Project	IEEE 802.16 Broadband Wireless Access Working Group < http://ieee802.org/16 >	
Title	Crypto synchronized HMAC	
Date Submitted	2004-05-17	
Source(s)	JunHyuk Song, Lim Geunhwi, Yong Chang Samsung Electronics	Voice: +82-31-xxx-xxxx Fax: mailto: junhyuk.song@samsung.com
Re:	This is a response to a Call for Comments IEEE 802.16e-03/58 on IEEE 802.16e-03/07r5	
Abstract	This document contains suggestions to provide crypto synchronized HMAC to protect certain MAC management messages against reply attack	
Purpose	The document is submitted for review by 802.16e Working Group members.	
Notice	This document has been prepared to assist IEEE 802.16. It is offered as a basis for discussion and is not binding on the contributing individual(s) or organization(s). The material in this document is subject to change in form and content after further study. The contributor(s) reserve(s) the right to add, amend or withdraw material contained herein.

802.16e Crypto Synchronized HMAC Message Authentication

Samsung Electronics

Figure-1

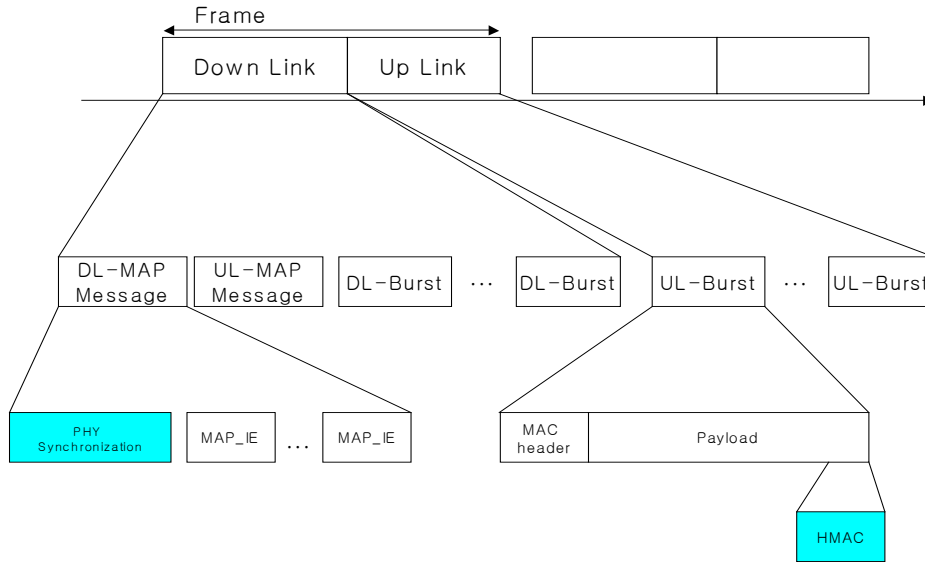
Crypto Synchronized HMAC Digest shall be computed as below:

- HMAC (160bits) = SHA1 (HMAC_KEY_D/U XOR opad, SHA1(HMAC_KEY_D/U XOR ipad, text))
 - ipad (512 bits) = 0x36 repeated 64 times
 - opad (512 bits) = 0x5c repeated 64 times
 - text = DL_MAP PHY Synchronization field (32bits) XOR LSB 32bits of MAC Management messages
